All comments from Appeal B Ref: APP/R5510/W/24/3347534

#### Proposal:

Re-finishing of existing roof material with;

EAST ELEVATION

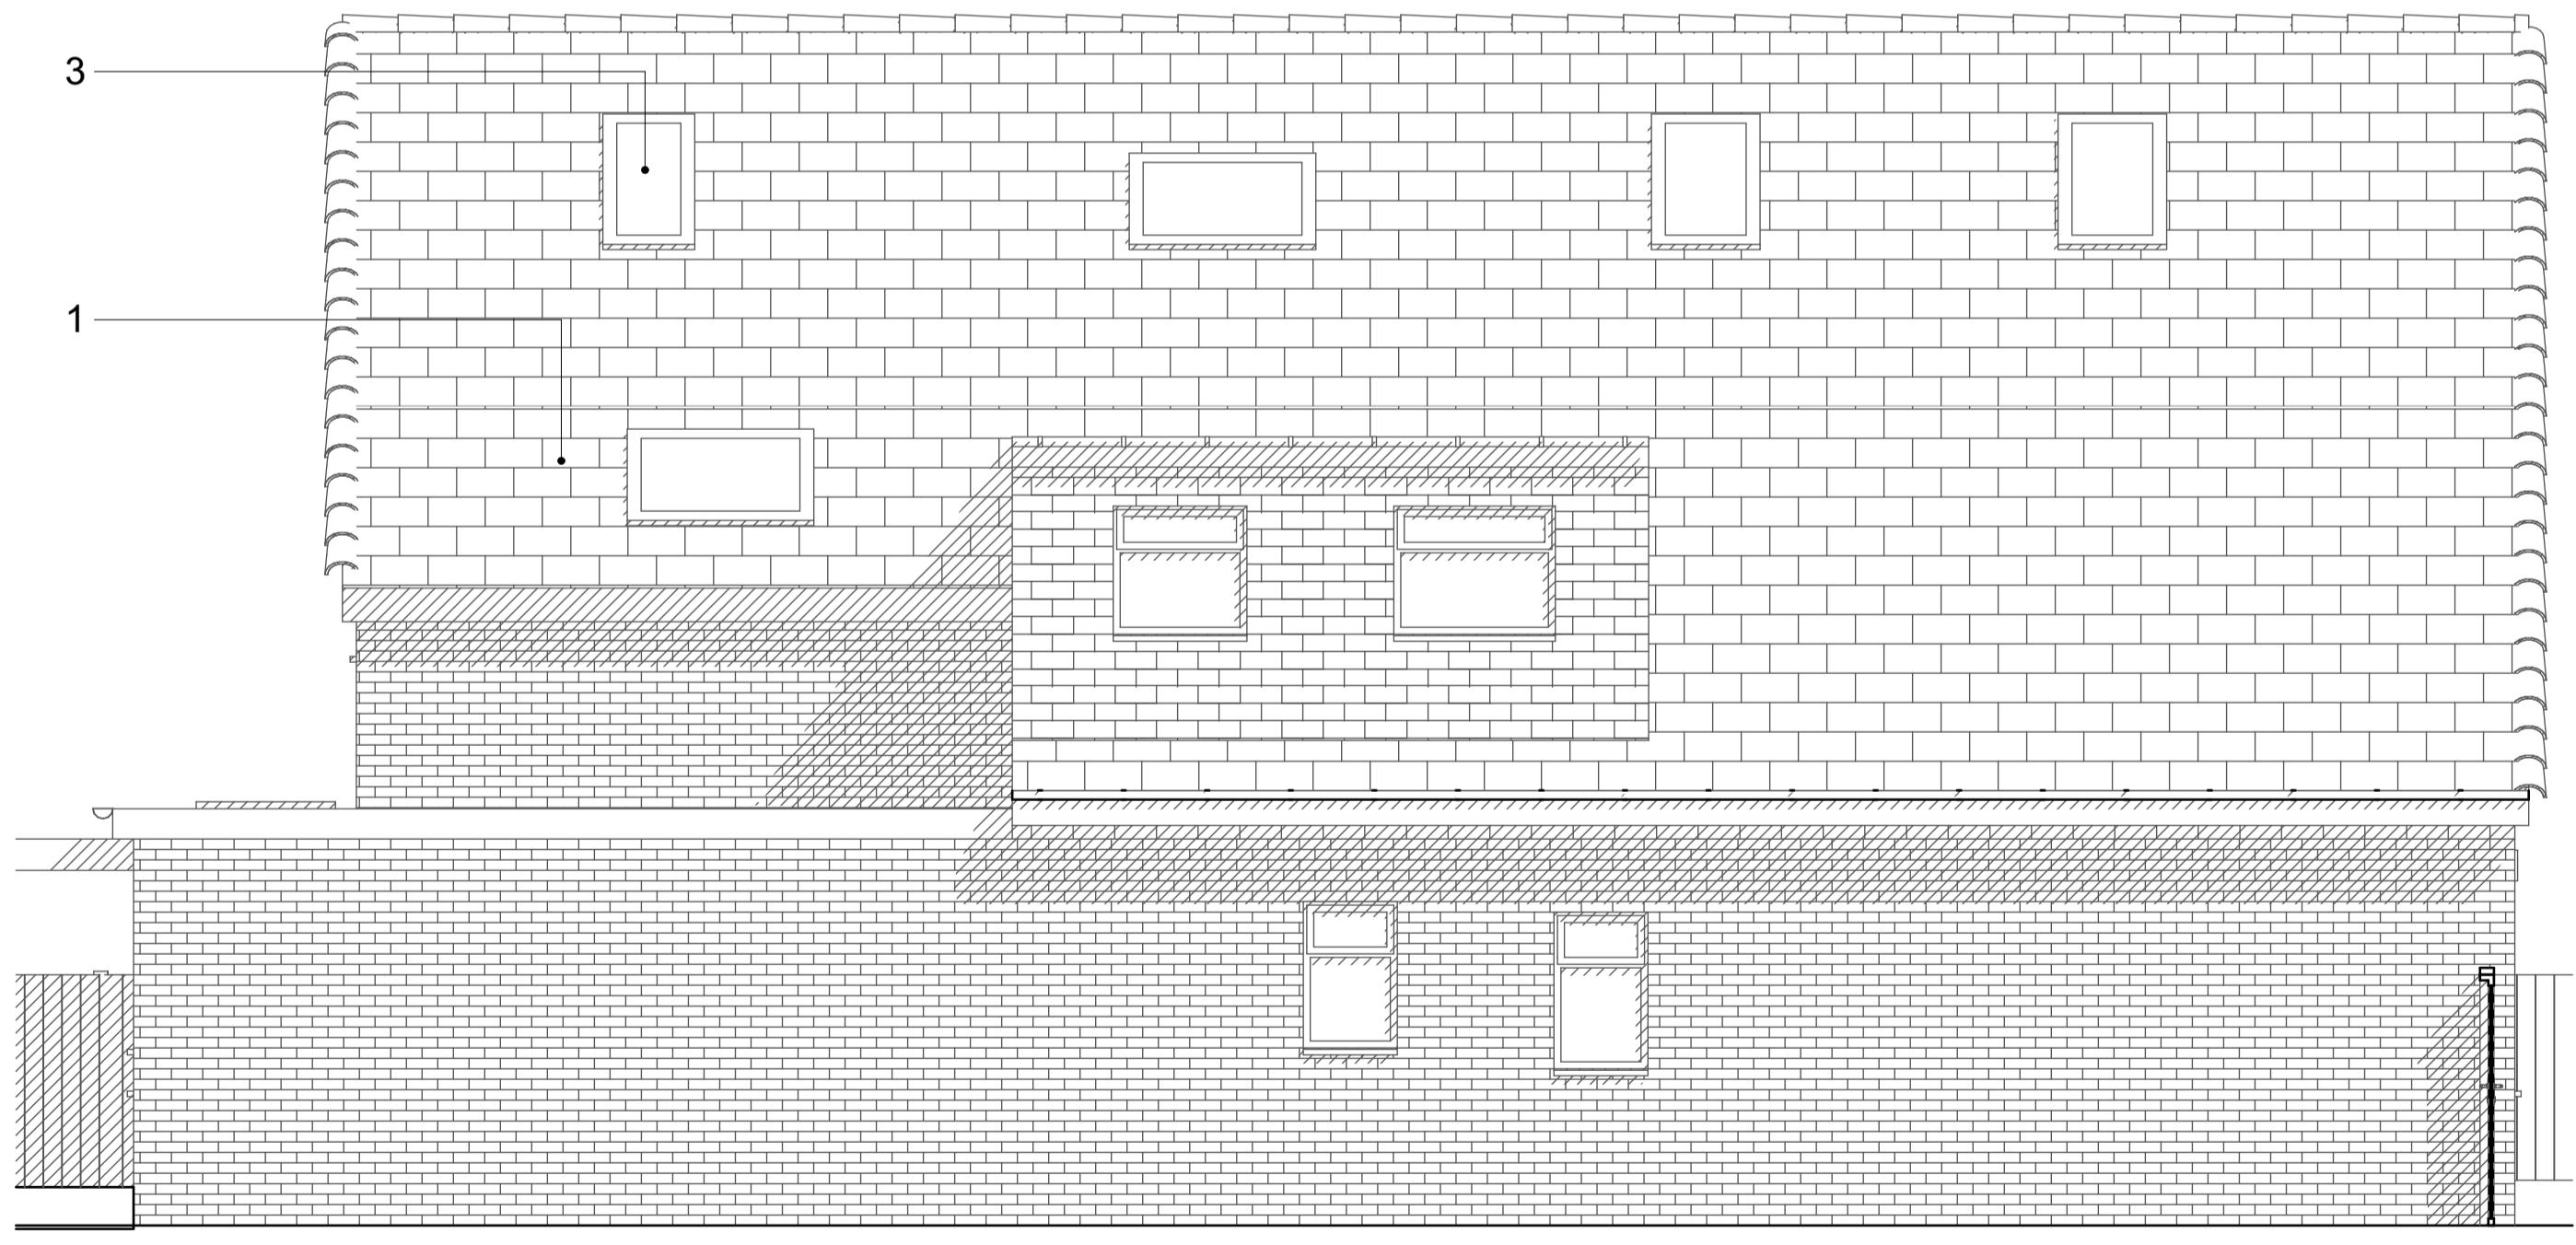
'The appellant, in their appeal submissions, has put forward an option for alternative materials or finishes to the roof and I am satisfied that a more appropriate finish would fit with the character of the area and overcome the identified harm. Such a proposition could be required by conditions to secure an acceptable alternative.'

**ClimaShield by SmartSeal - Roof Coating Sealer & Tile Paint - Burgundy. 10yr + Lifespan UV Resistant and Breathable Protective Roof Coating.**

1 & 2 Roof Re-finishing - Climashield Burgundy Roof Coating
